CONDITIONS OF APPROVAL:

Engineering - PUD Plan Checklist

30. G. Grading Plan

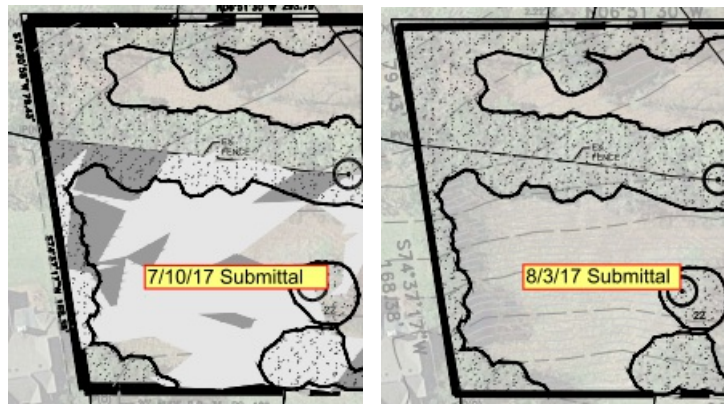
joe.marlo@franklintn.gov *The following is an Advisory Comment and **does not hinder approval of the Development Plan.***

The storm infrastructure added in Jordan Road does not appear to be positioned to accept offsite flow from the ditch section in the northwest corner of the site. When detailed grading is determined at the Site Plan stage, the storm infrastructure shall be designed and located to accept flow from the upstream ditch section. The headwall shown at the outlet shall be located a minimum of 10 feet from the sanitary sewer manhole, and no portion of the infrastructure shall be located in a stream buffer.
